HOLDOVER

Revised

HUNTER'S PARK SUBDIVISION, UNIT V

APPLICATION NUMBER Holdover DATE February 2, 2006

DETAIL SITE PLAN

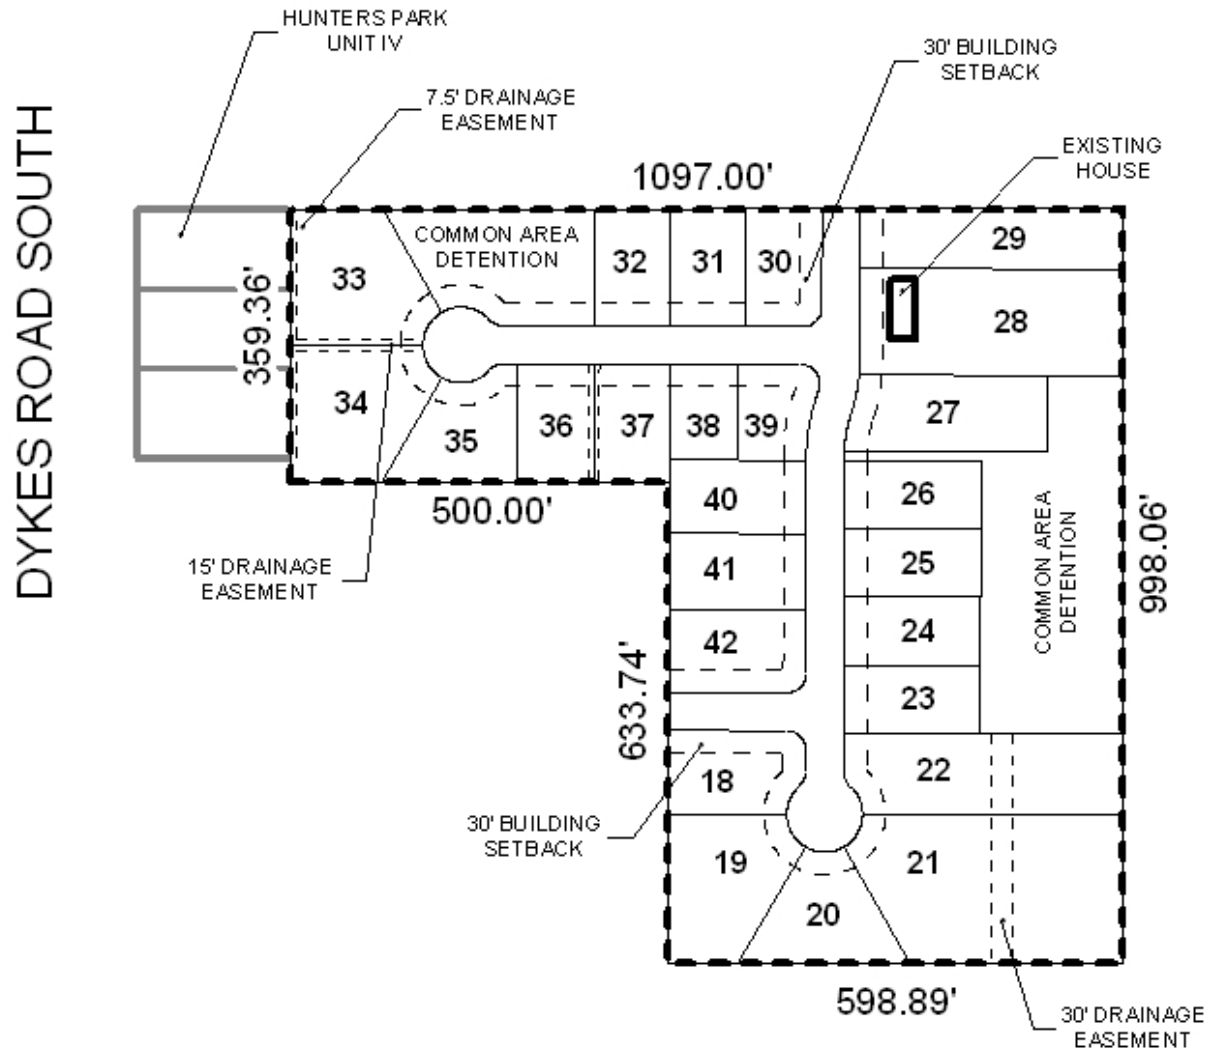
The lots meet the minimum requirements of the Subdivision Regulations, but the site, adjoining several existing and proposed residential developments, presents some issues and opportunities regarding street connectivity.

Unit IV would prevent the proposed East-West street in Unit V from connecting to Dykes Road South, which is an undesirable outcome for the overall site. Minor street connections benefit neighborhoods by allowing dispersion of traffic, more access points for emergency vehicles, and more efficient distribution of roads and utilities; Units IV and V present unusually good opportunities to increase the connectivity of existing and proposed neighborhoods.

The plat illustrates a stub North connecting to Summerlake and one West to Unit III. By extending the proposed East-West cul-de-sac to Dykes Road South through the Unit IV property, traffic would be alleviated for adjoining streets in Hunter's Park and Summerlake, and the neighborhood would become more accessible by emergency vehicles.

This application was held over from the January 19th meeting, to allow the applicant to submit revised materials coordinating Units IV and V, to increase the connectivity of the streets. The applicant's engineer has not submitted any additional materials, but has noted that a portion of the previous report was in error; the site does not in fact adjoin Summerlake subdivision. Nevertheless, the provision of a street connection through Unit IV, rather than terminating the new road in a cul-de-sac, is strongly recommended by Urban Development. As this would impact proposed lots 33, 34, and 35, they should be configured to ensure that they maintain the minimum lot size required for a site served by public water and sanitary sewer (7200 square

feet). Furthermore, as the road would exceed 600 feet in length, traffic calming would be required.

It should also be noted that Units III and IV of Hunter's Park (SUB2005-00223) received Tentative Approval in 2005, and the present application reconfigures and adds to the original layout for Unit IV, and encompasses approximately 20 feet of the northern side of Unit III. Associated files and parcels will be tagged to identify this slight deviation, since it is part of the overall development. However, if the original Unit IV is recorded, the present approval (if granted) will become void.

The site otherwise meets the minimum requirements of the Subdivision Regulations. Based on the preceding, this application is recommended for Tentative Approval, subject to the following conditions: 1) revision of the plat to show a street connection between Dykes Road South and the new street in Hunter's Park Unit V; 2) reconfiguration of the lots to ensure that minimum lot size (7200 square feet where served by public water and sanitary sewer) is maintained; 3) construction and dedication of the new streets to County Engineering standards; 4) the provision of a traffic-calming device in the center of the new East-West street, subject to County Engineering approval; 5) the placement of a note on the final plat stating that maintenance of the common and detention areas shall be the responsibility of the property owners; and 6) the placement of a note on the final plat stating that any lots that are developed commercially and adjoin residentially developed property must provide a buffer, in compliance with Section V.A.7 of the Subdivision Regulations.
